North Revilla Final Environmental Impact Statement

Ketchikan Pulp Company
Long-Term Timber Sale Contract

RECORD OF DECISION

VCU: 7390UNIT NUMBER: 9050

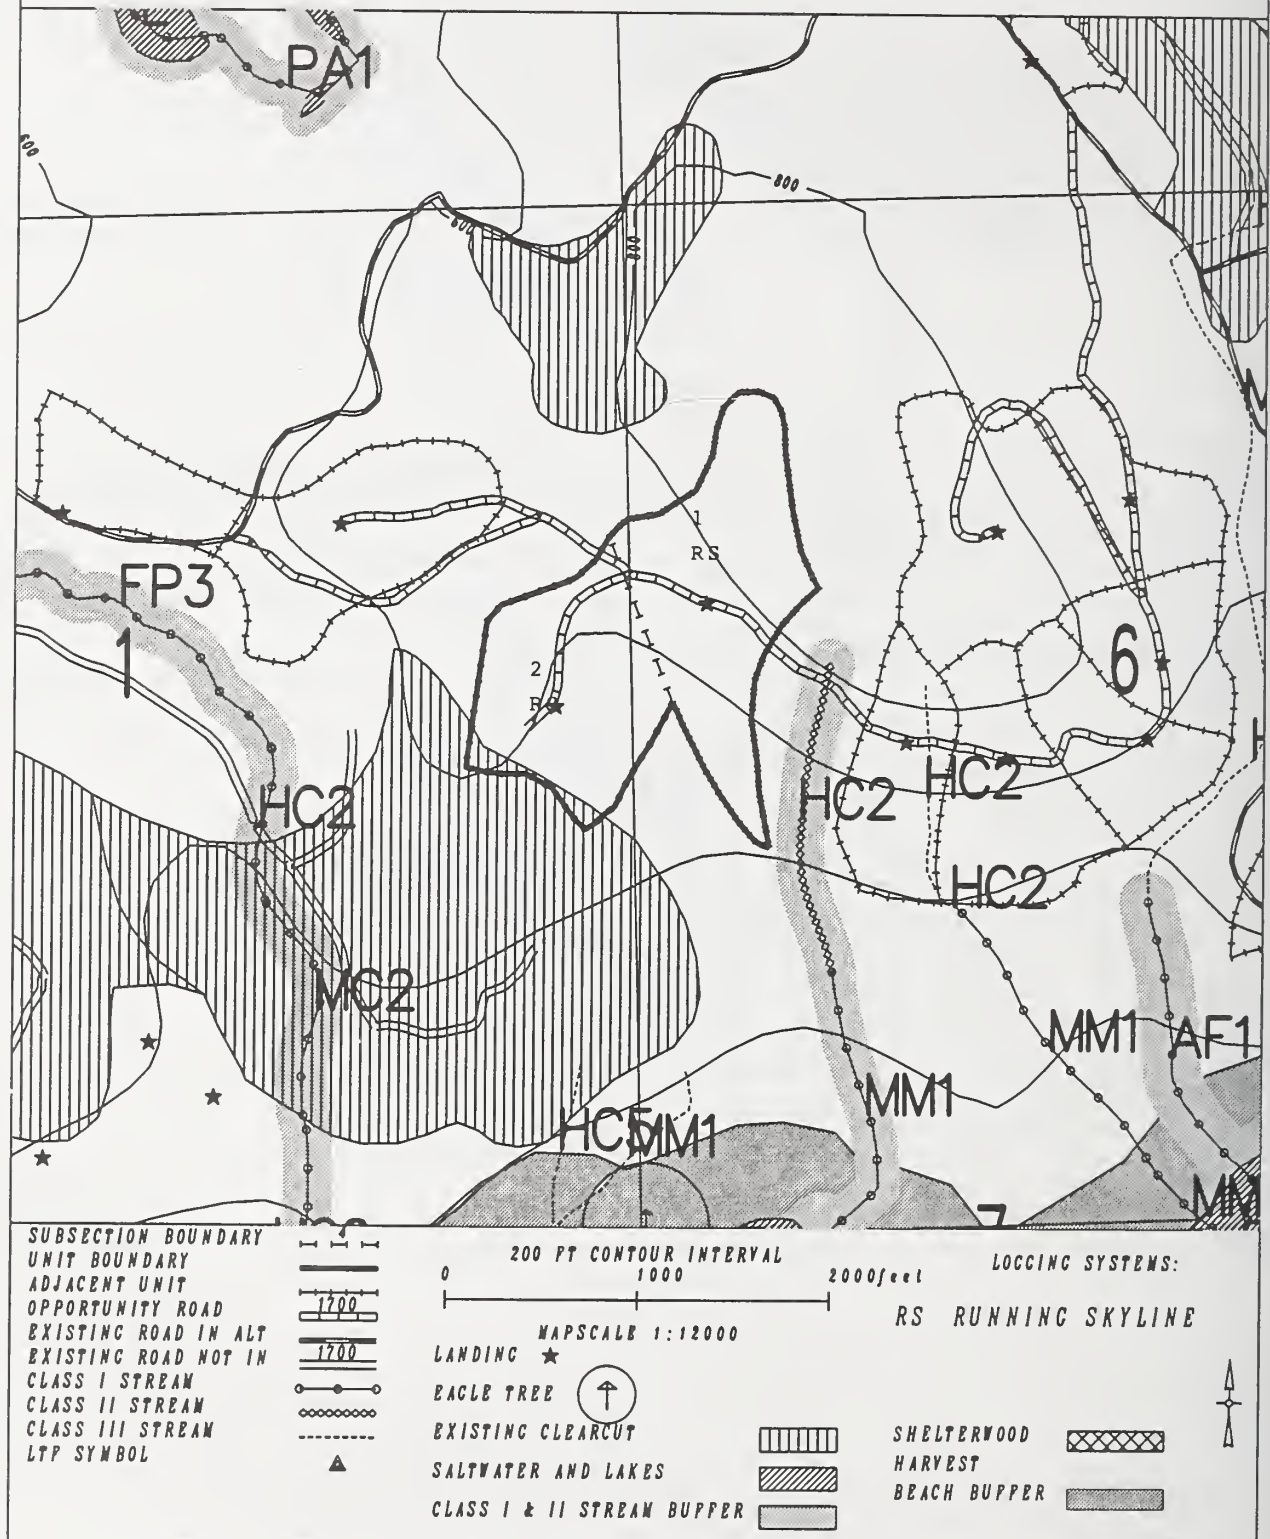
Unit 9052 - Expand the unit boundary to the south to minimize the potential for windthrow, and change the yarding system to Slackline to minimize soil disturbance. Relocate the access road from unit 9051 to access from unit 9050, this will reduce road and haul costs.

VCU: 7390UNIT NUMBER: 9051

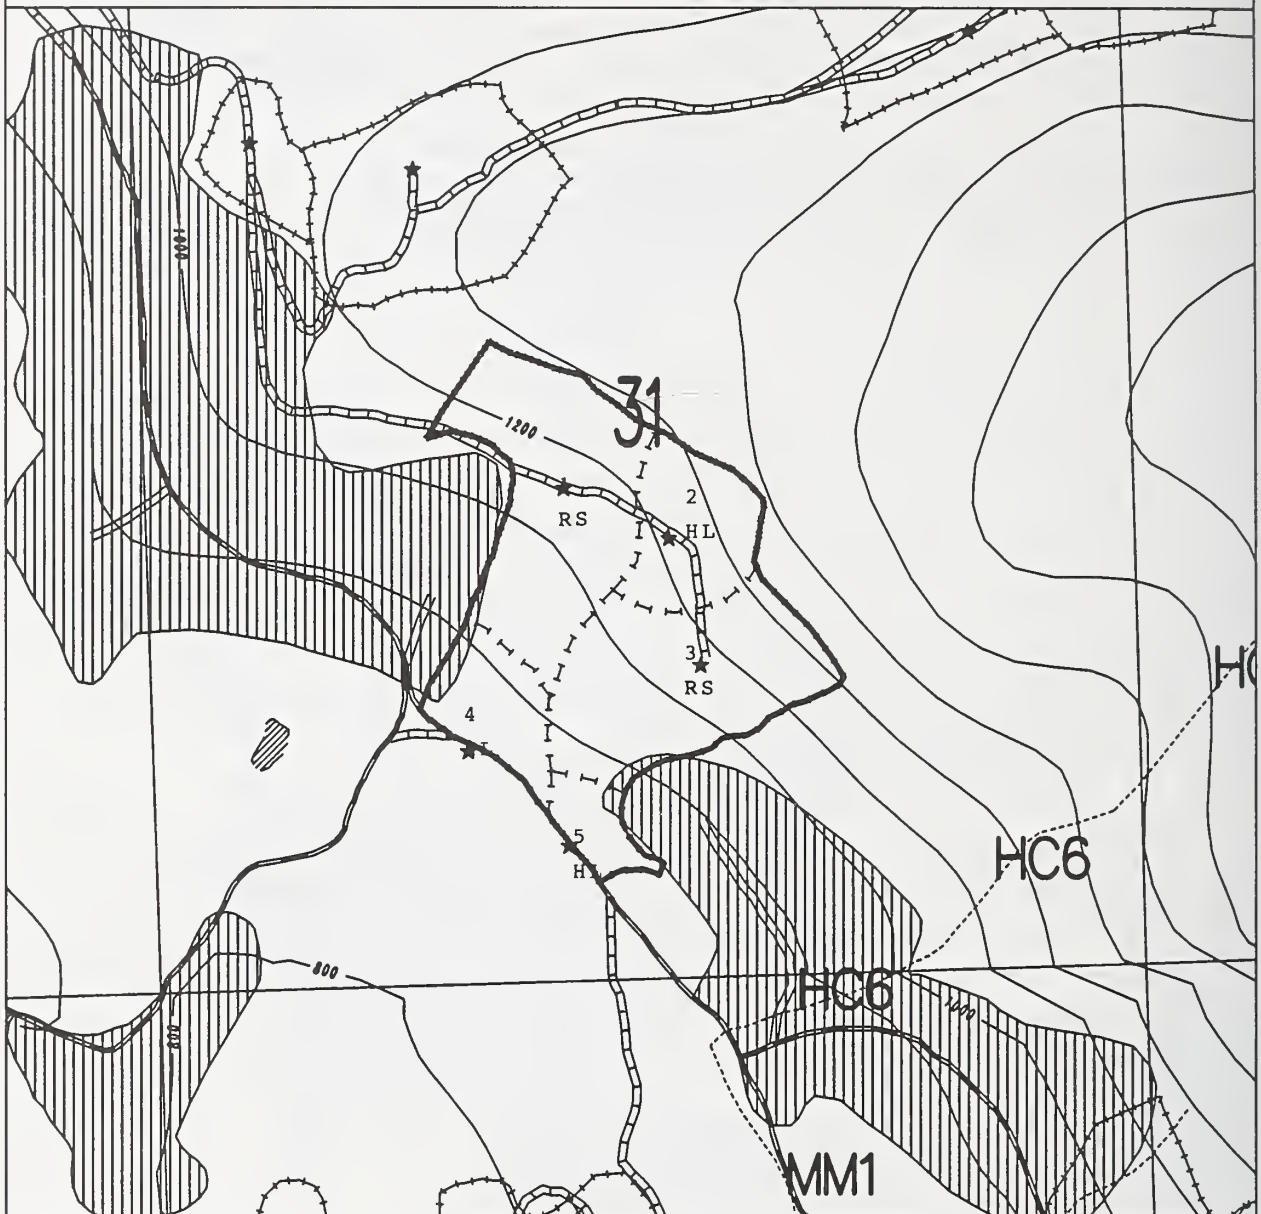
Unit 9051 - Delete southern most portion of unit to protect wetlands and address fisheries concerns. Locate midslope road through unit to access harvest unit 7048.

VCU: 7390UNIT NUMBER: 9569

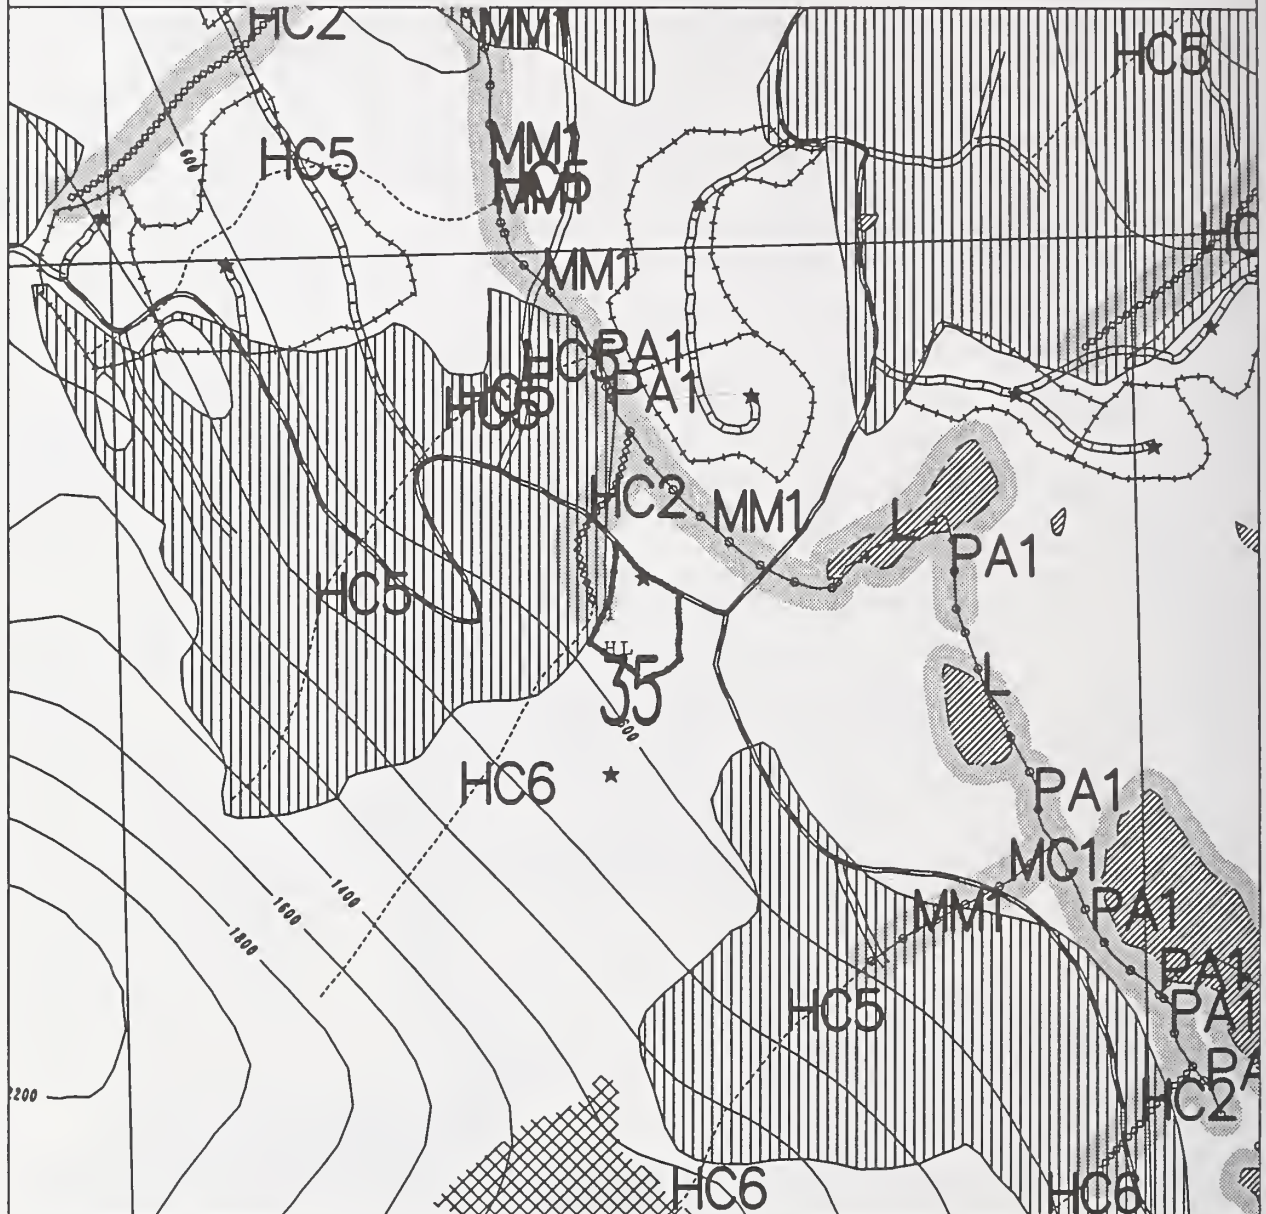
Unit 9569 - Delete the portion of the unit below the road and change the yarding system to Running Skyline to minimize impacts to Class I stream and wetlands.
